AGENDA
DANIA BEACH CITY COMMISSION
REGULAR MEETING
TUESDAY, OCTOBER 24, 2017 - 7:00 PM

The applicant is proposing the use of incentives to achieve a building height of six stories, 67 feet. Based on the Incentive table provided on Sheet A-040, received on 10-13-17, the applicant is proposing to provide ten (10) public parking spaces via Payment in Lieu of Parking. Therefore a total of \$65,000 must be paid to the City, of which half, or \$32,500, must be paid prior to issuance of a building permit. The remaining \$32,500 must be paid prior to issuance of the Certificate of Occupancy. Utilization of this incentive will earn the applicant one additional floor.

2
A-040
OFF-SITE VALET PARKING SITE PLAN
1/16" = 1'-0"

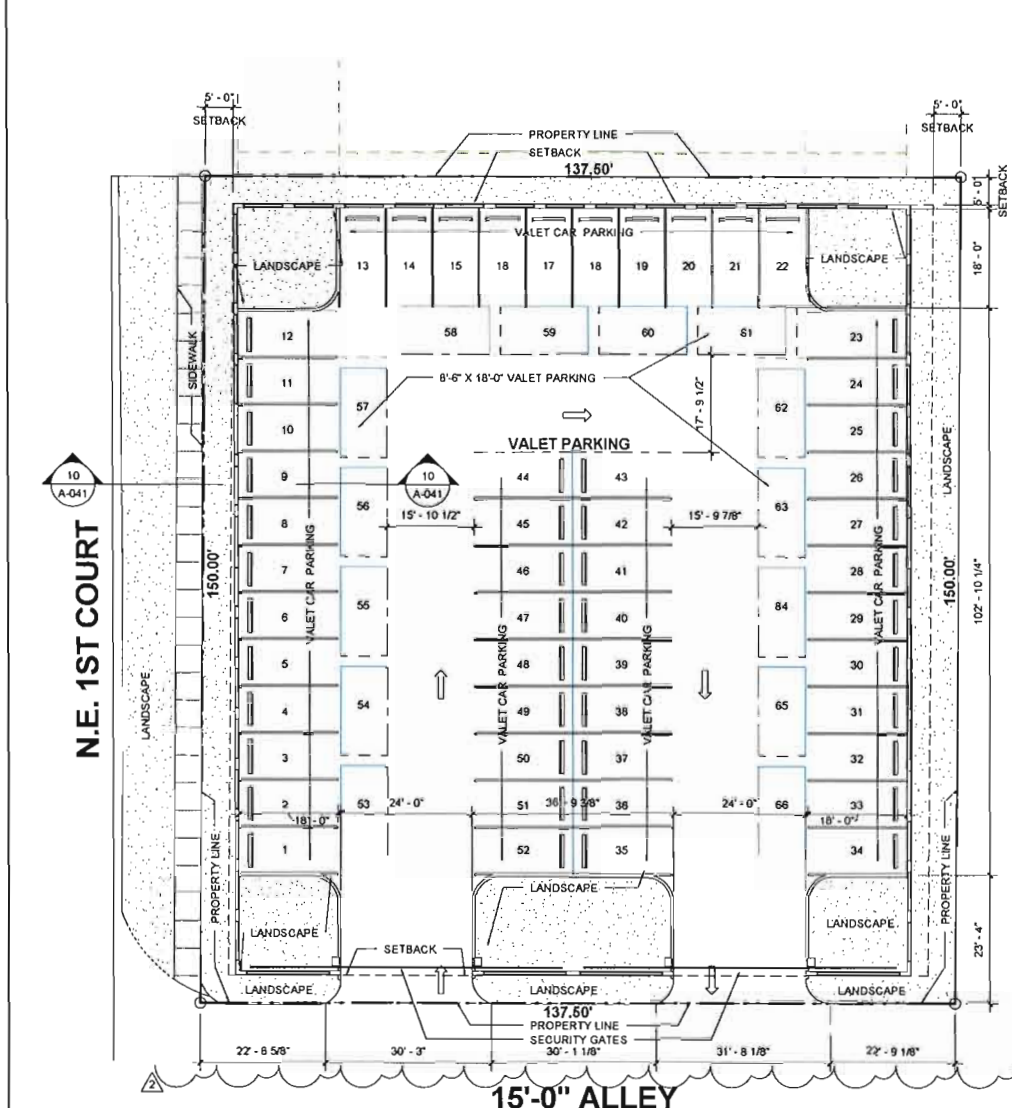
12. Based on the Incentive table on Sheet A-040, received on 10-13-17, the applicant is proposing to provide ten (10) public parking spaces via Payment in Lieu of Parking. Therefore a total of \$65,000 must be paid to the City, of which half, or \$32,500, must be paid prior to issuance of a building permit. The remaining \$32,500 must be paid prior to issuance of the Certificate of Occupancy.

13. Based on the Incentive table on Sheet A-040, received on 10-13-17, the applicant is proposing to provide Public Park incentive payment in the amount of \$26,501 (payment of \$.50 per square foot of residential gross floor area – including hotels; 53,003 sf X .50 = \$26,501). Therefore, payment of \$26,501 must be paid prior to issuance of a building permit.

31. Sheet A-040 provide detail of decorative galvanized fence, must meet the requirement of Section 309-40. 2nd time requested. 3rd time requested.

32. Sheet A-040, Hotel Site Project Data Table, correct "Adjacent Zoning" to be City Center to the north, south, east and west, NBHD-RES/MA/C-3 shown. 4TH TIME REQUESTED.

33. Sheet A-040, Project Data Table, correct "Current Use" as property is not vacant, a building exists with 2 tenants + residential. Revise accordingly. 3rd time requested.

44. Per Section 303-40(M) & 520-50(E)(3) min. depth of 1st layer = 30'. Identify required and provided in table and provide measure on site plan drawing. Sheet A-040 identifies 24' 5 1/4". Revise accordingly or request a Design Variation. 3rd time requested.

1 Dumpster Plan View
1/4" = 1'-0"

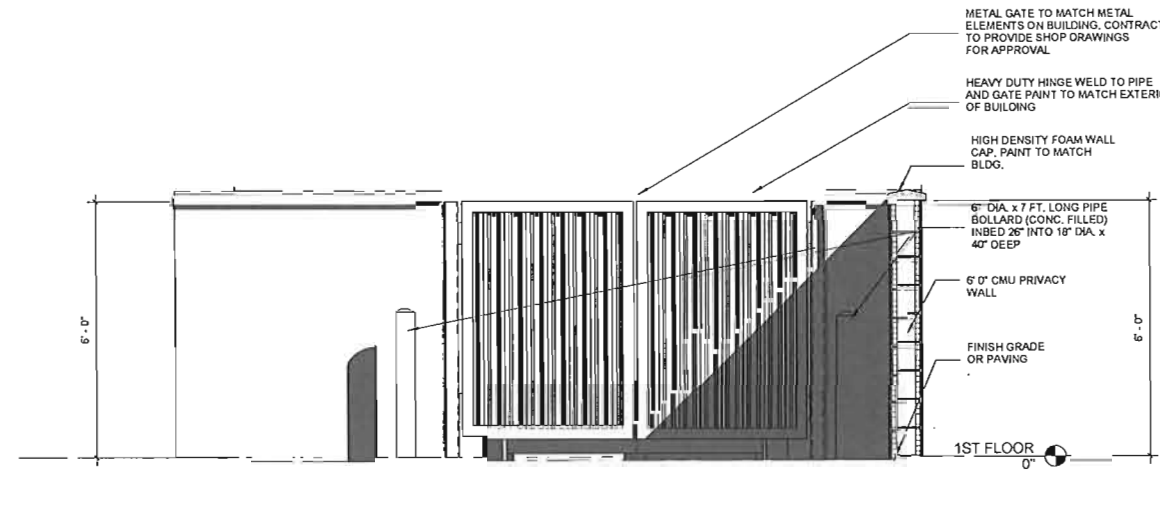
28. Dumpster detail #8/A-041 provided on Sheet A-041 does not identify height. Revise accordingly. 3rd time requested.

1 SIGNAGE DETAILS-NORTH FACADE
A-304 1/2" = 1'-0"

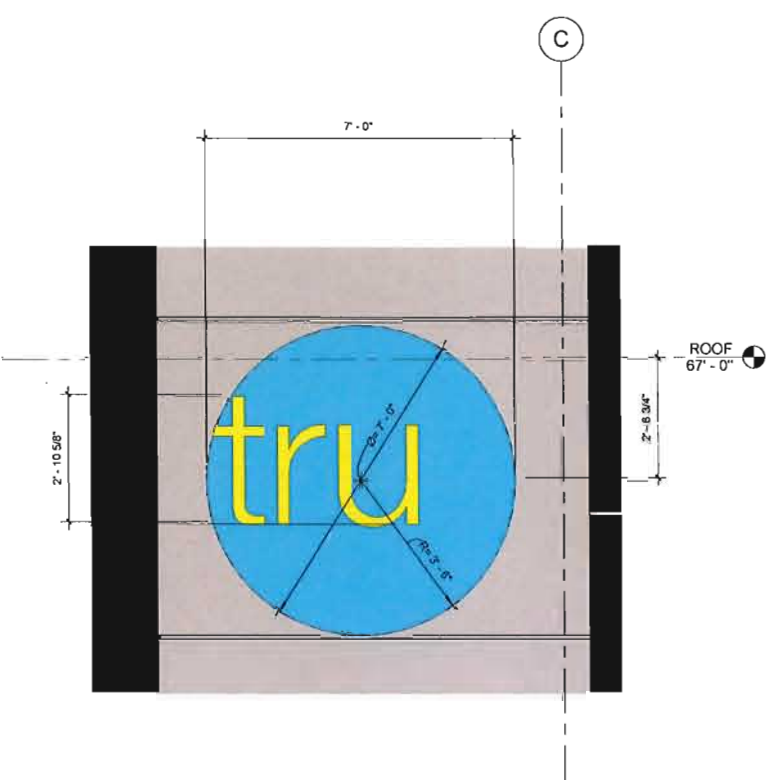
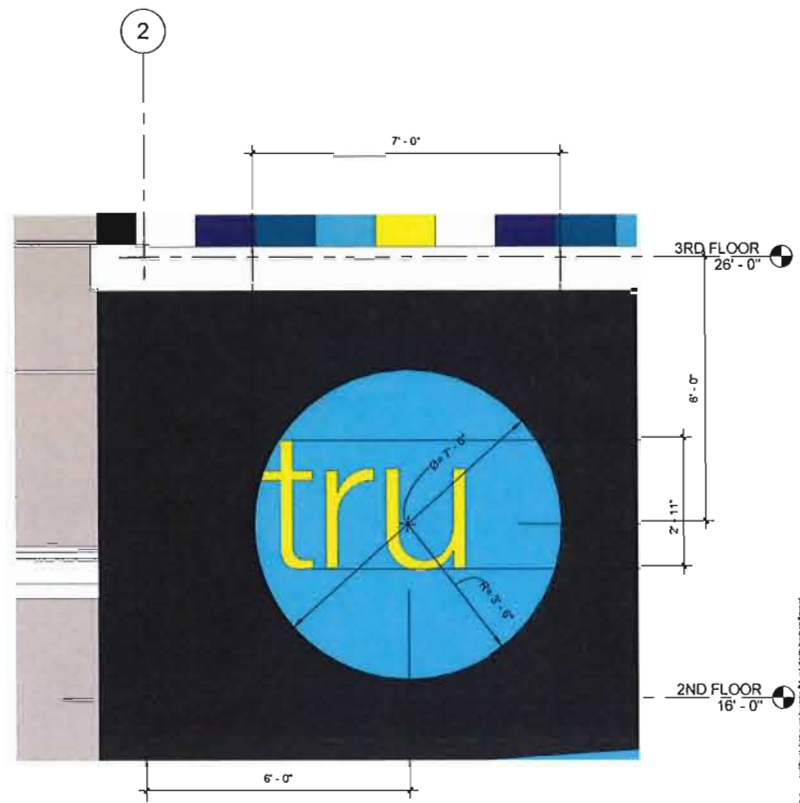
5. Revise Sheet A-304, Signage SQ. FT. Requirements Table, removing the frontage notes for the north and south facades, as the north and south property lines internal side lot lines that do not have any street frontage, there for should be zero (0). Revise accordingly.

6. Revise Sheet A-304, Signage SQ. FT. Requirements Table, removing the reference to CRA Sign Bonus and correcting the allowable sign area to 93.75 square foot sign area permitted per street frontage. Revise accordingly.

- Per Section 505-90(C) identify cumulative sign area permitted and used. 1.5 s.f. of sign area permitted per linear foot of occupant street frontage. The north and south sides of this property are not street frontages, therefore 0 s.f. of sign area is earned. Revise Allowed/Provided accordingly.
- Sheet A-304, identify dimension of address, per Section 505-40(A)(2)(c). "All address signs shall have a minimum 6" and maximum 10" letter height."
